| NUMBER 077 (REV 1, 01/29/2016) | DATE December 2014 |

TECHNICAL SERVICE BULLETIN

SUBJECT: REAR VIEW CAMERA DIAGNOSIS/REPLACEMENT

Diagnostic Flowchart:

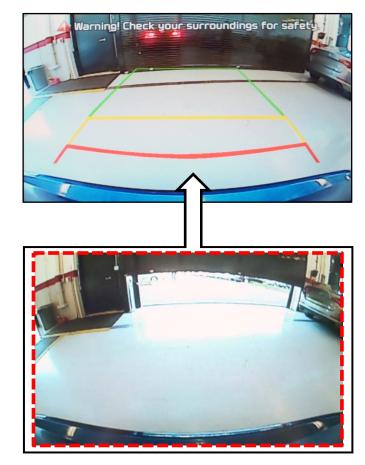
- 1. Check for blurry image quality on the AVN screen.
- 2. Inspect the rear view camera lens for signs of condensation forming on the inner surface of the lens and/or possible discoloration or water stains.
- If water intrusion is evident, replace the rear camera module by referring to the applicable service procedure on KGIS.

- For customer complaints related to intermittent operation from the rear view camera, perform the following checks:
 - Confirm the parking guidelines are displayed on the AVN screen. If the guidelines are present and the vehicle owner resides in an area with high humidity, snow or rain, replace the rear view camera with an improved part.

1. If the AVN screen is missing the Parking Guide Lines or displays a black or blank screen, check the AVN system for proper operation:

- 2. If the AVN system is functioning properly, perform the following checks:
 - Check the rear view camera wiring harness for pinched or damaged wires.
 - Place the transmission in reverse and confirm the AVN screen switches to rear view mode. If not, check for 12V signal at head unit.
 - If no 12V signal is found at head unit, check the transmission range switch circuit.
